Certificate of Appropriateness Case Report

Filing Date: March 25, 2014
Case No.: **2014.0424A**
Project Address: **2319 Webster Street**
Landmark District: Webster Street
Zoning: RH-2 (Residential, House, Two-Family)
40-X Height and Bulk District
Block/Lot: 0605 / 003
Applicant: Virginie Manichon
EAG Studio
2443 Fillmore Street, #215
San Francisco, CA, 94115
Staff Contact Alexandra Kirby - (415) 575-9133
alexandra.kirby@sfgov.org
Reviewed By Tim Frye - (415) 575-6822
tim.frye@sfgov.org

Historic Preservation Commission Draft Motion XXXXX

2 PROPOSED EAST ELEVATION
1/4" = 1'-0"

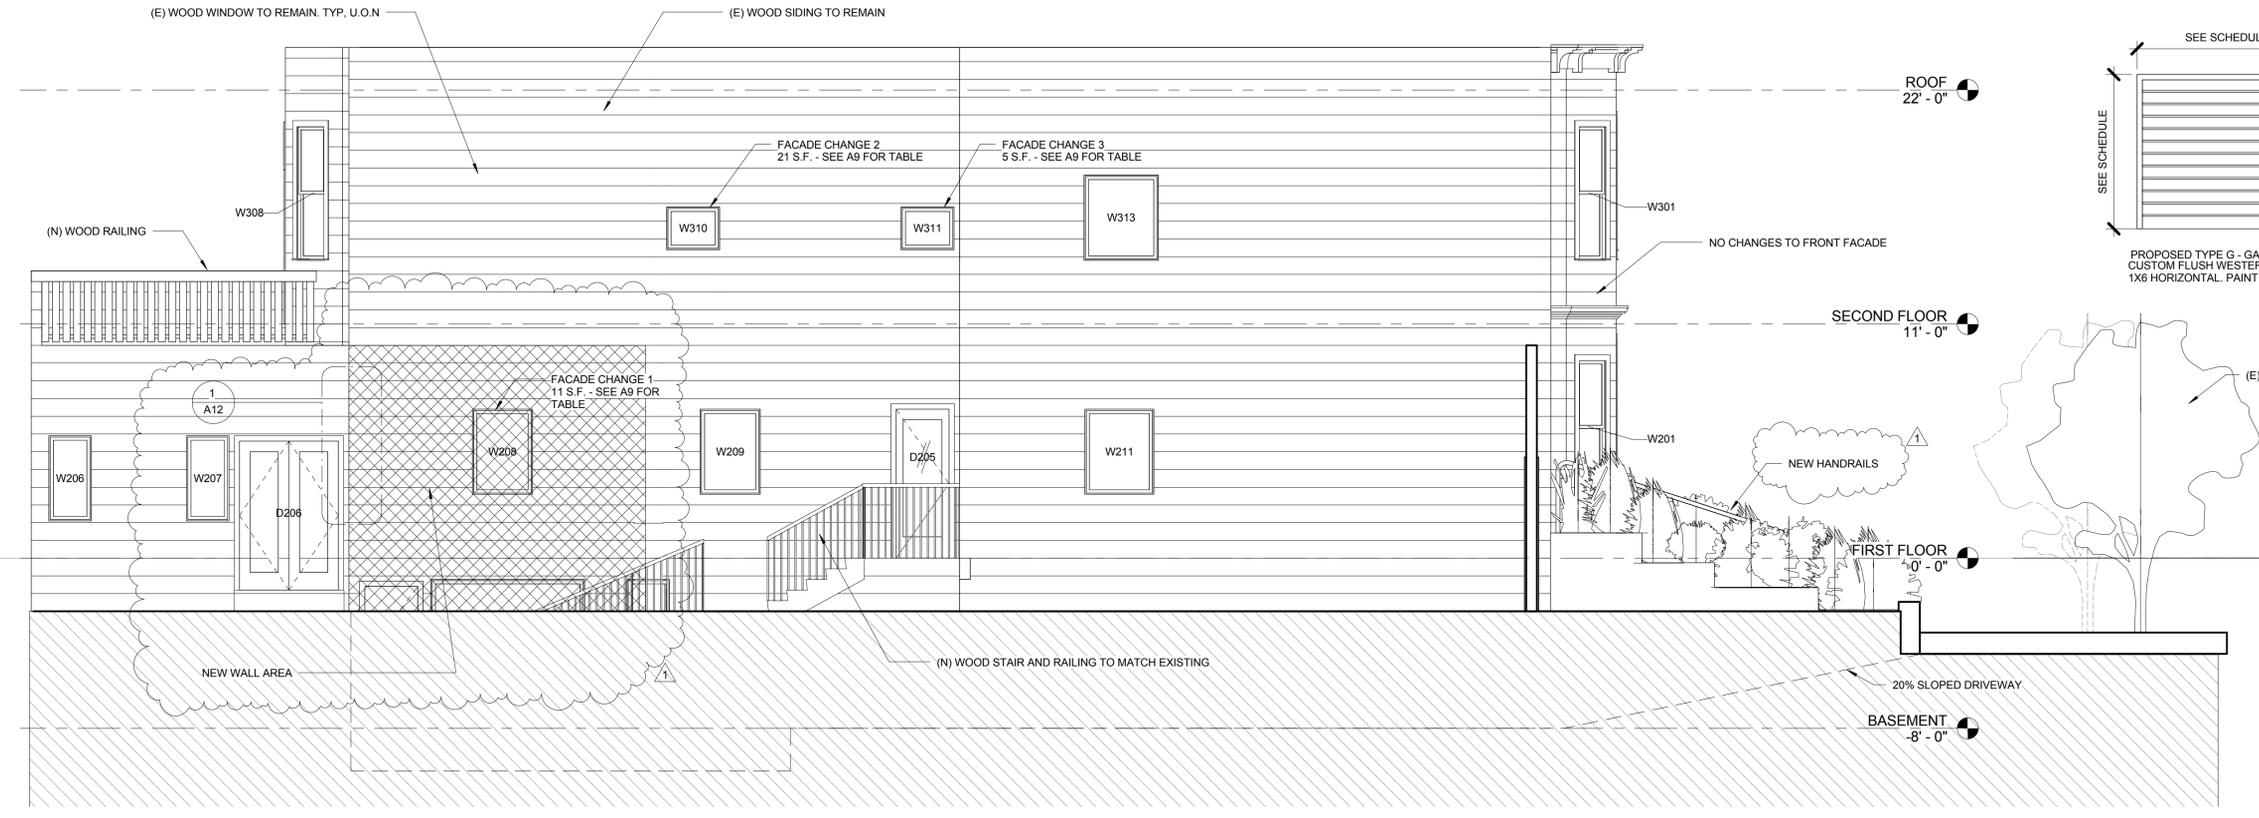
Primary Façade: *Garage*

Staff finds that the modified garage entry will not destroy significant historic material and will retain the spatial relationships of the building and district. The proposed garage will be clearly contemporary in its design and would not create a false sense of historical development in the Webster Street Landmark District. The garage design is in keeping with the existing garages installed at the two adjacent properties to the south within the district, among others, which feature minimal surround trim, painted wood doors with simple designs, are installed entirely below the projecting bay windows, and are typically partially below grade to further reduce visibility. The proposed garage door would be 8'-6" wide and 7' tall, constructed of cedar with a painted exterior to match the historic residence. The wood trim surrounding the door will be 1" by 4", with a 1" by 5" moulding above. The garage will be set 2'-4" behind the face of the projecting bay, where the existing historic wall is located.

The garage design will retain the openness of the front yard and will retain the existing straight-run entry stairs. The proposal would remove the existing curb, retaining walls, and planters that the front of the residence. The proposed planters at either side of the permeable driveway will retain plantings in the yard area and soften the transitional space between the street and the building. The finish has not been specified, therefore the Department recommends that the project sponsor use a smooth-finished concrete along the walls of the proposed planters as a condition of approval. The work will cause the removal of less than 25% of the building's exterior walls and less than 25% of the surface of the front wall.

- The project sponsor shall use a smooth-finished concrete wall for the new retaining walls and planters flanking the driveway to maintain a simple aesthetic from the public right of way.
- The project sponsor shall retain the historic base of the bay on the primary façade above the proposed garage and install a solid wood garage door with a painted finish similar in tone to the surrounding wall finishes.
- The project sponsor shall complete a site visit with Department preservation staff prior to occupancy in order to verify compliance with the approved project description and conditions of approval.

2 PROPOSED WEST ELEVATION
1/4" = 1'-0"

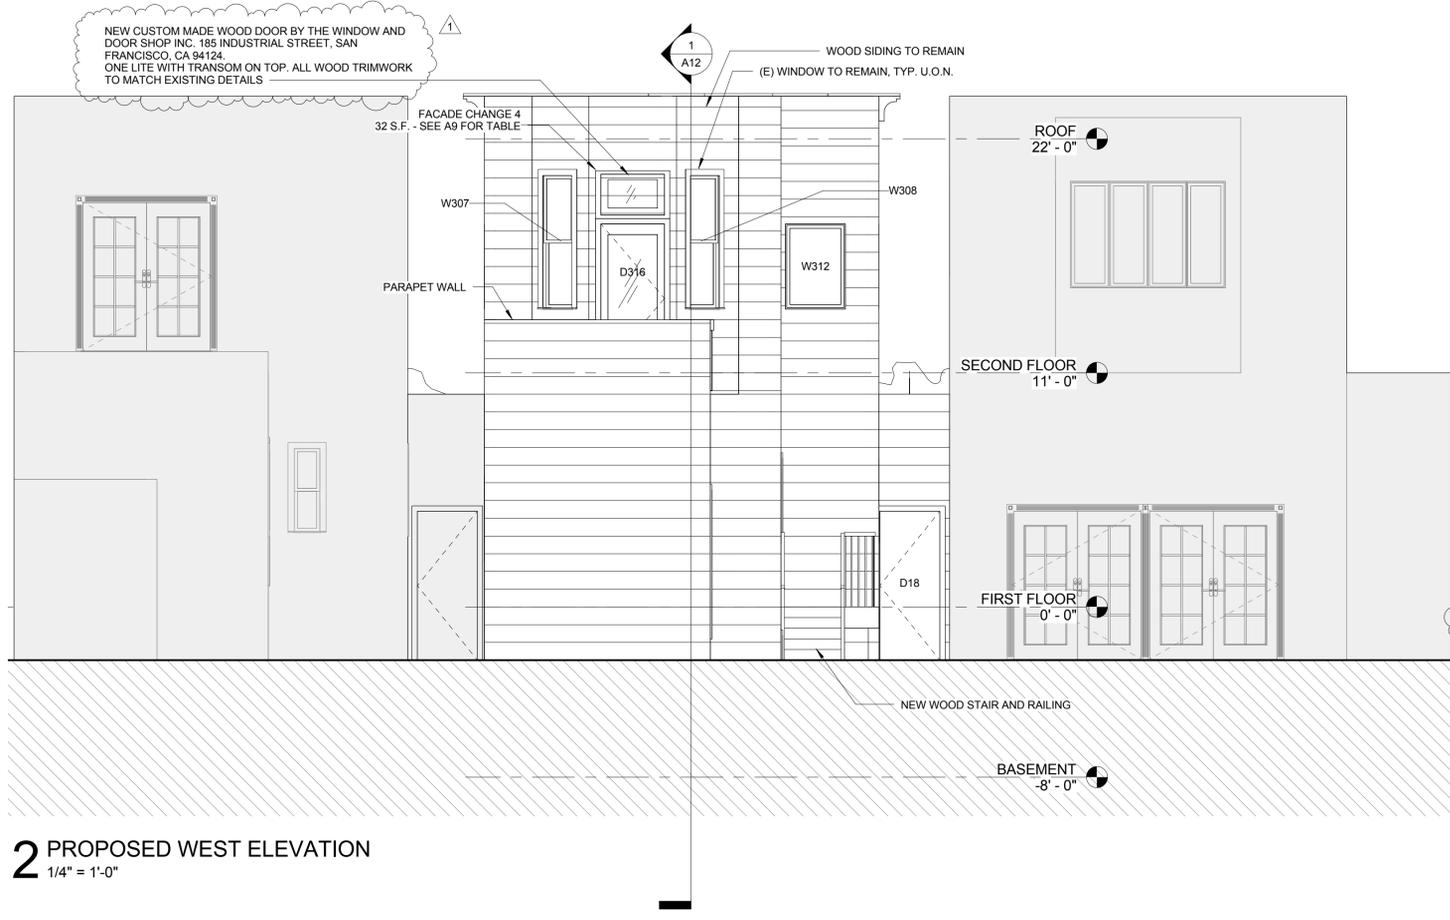
Rear Façade: *Deck*

Staff finds that the addition of a deck to the existing roof of the rear single-story addition will not destroy significant historic material and will retain the spatial relationships of the building. Additionally the alteration will not be visible from the public right-of-way. The materials specified for the deck alteration and addition of a rear door would be in alignment with the district's character-defining features, which include wood siding, wood framed doors, and framed windows. Further, the general proportions of the windows adjacent to the proposed door would be retained in the design of the door.
